Staff Report

Infill Housing Design Review Committee

File Number: 10-B-23-IH

Location: 1434 Cornelia St. **Parcel ID** 81 L R 001
Zoning: RN-4 (General Residential Neighborhood)
District: Oakwood/Lincoln Park Infill Housing Overlay District

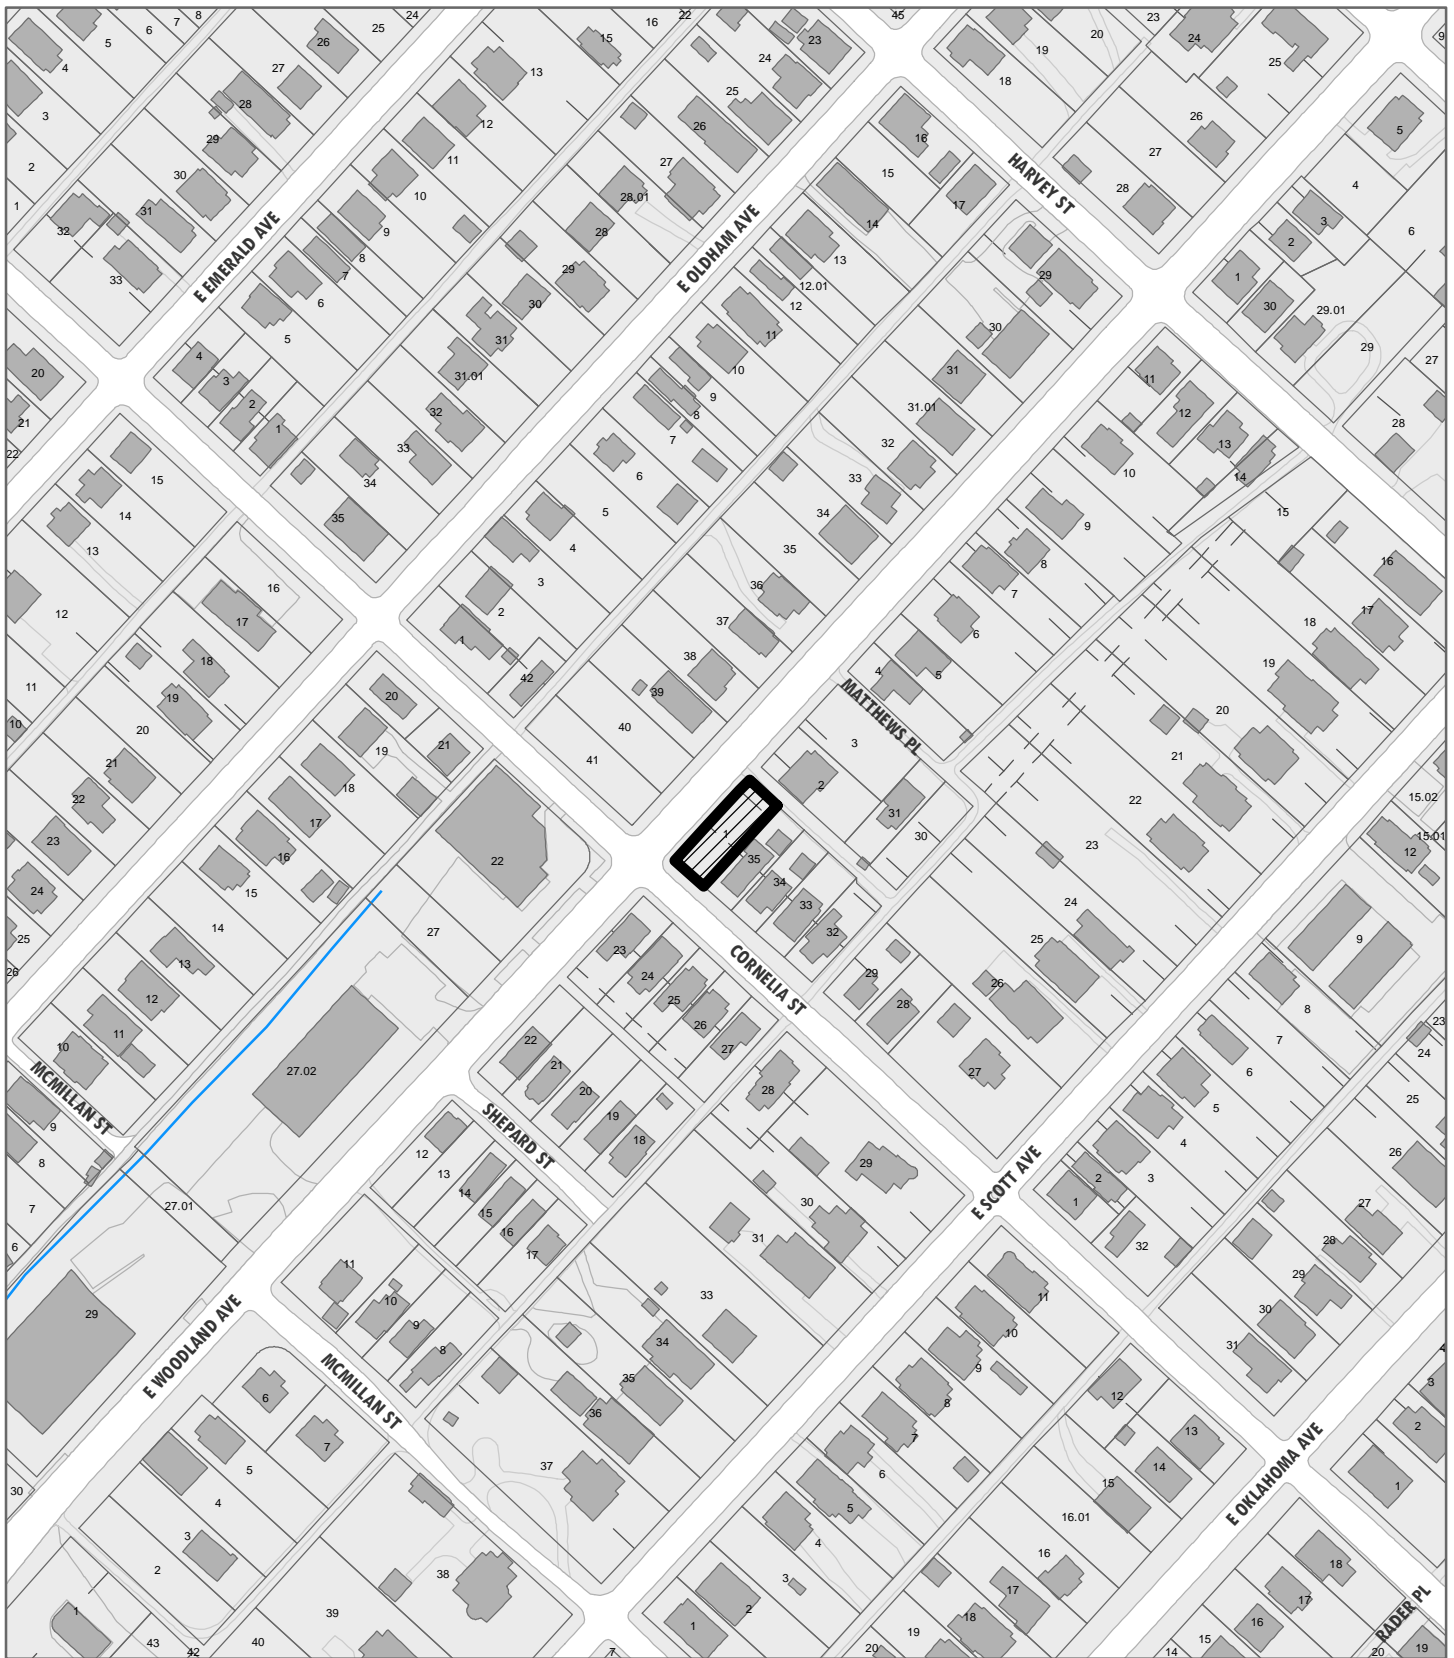
1. The house is proposed to be set 18' from the front property line. The average front setback of the block is 14.5'. The adjacent house is set 15' from the front property line, and houses get closer to the street moving south on the block. The proposed placement is appropriate for the block and will maintain a consistent streetscape. The site plan includes an 8' corner side setback on the left side; the side setback varied from the base zoning will maintain side setbacks similar to the block, though sight distance-related revisions may be required by City Engineering. The site plan includes a walkway to the sidewalk.

2. The block to receive new construction is characterized by Queen Anne cottages and houses, with some modified Craftsmans. The house is proportionate in width to the lot and the side setbacks are consistent with the block.

3. The proposed parking meets Infill Housing guidelines as it's located to the rear of the house and accessed from the alley. Final site plan revisions will be necessary to meet City Engineering standards.

LEFT SIDE ELEVATION

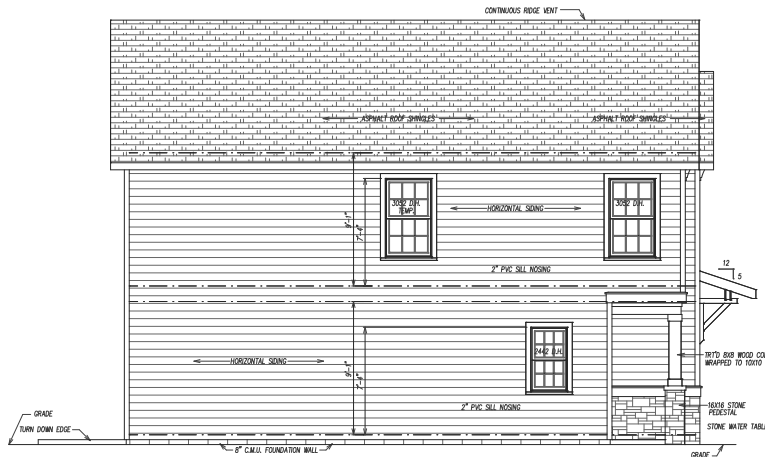
6. Guidelines recommend window and door styles be similar, with similar proportions and ratio of solid to void, to historic houses on the block. Revisions should be made to the large swath of siding on the façade where the elevation drawings have revised a front-facing garage. The left elevation should receive an extra window towards the rear, as the left side elevation will be prominent on Woodland Ave.

Staff recommends approval of Certificate 10-B-23-IH, subject to the following conditions: 1) final site plan to meet City Engineering standards; 2) foundation to be increased to at least 12" tall and clad in stucco; 3) revisions to front porch depth, with approval by staff; 4) revisions to façade and left side elevation window placement; 5) substituting brick veneer for stone veneer; and recognizing the reduced lot area as furthering principles associated with the Infill Housing guidelines.

FRONT ELEVATION

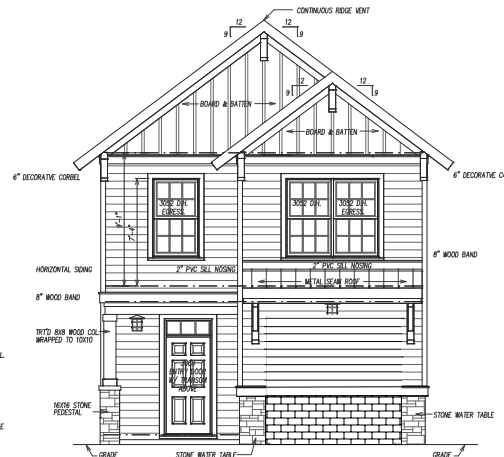
5. The recessed entry stoop is not proportionate to front porches in the neighborhood; a revised porch should project towards the street, measuring at least 8' in depth.

8. The application does not include information on siding materials. If vinyl siding is used, the siding should feature an overlap instead of Dutch lap or flush panel siding. The foundation should be clad in stucco. The stone veneer is not appropriate for the context and does not meet the design guidelines; stone-clad elements should be replaced
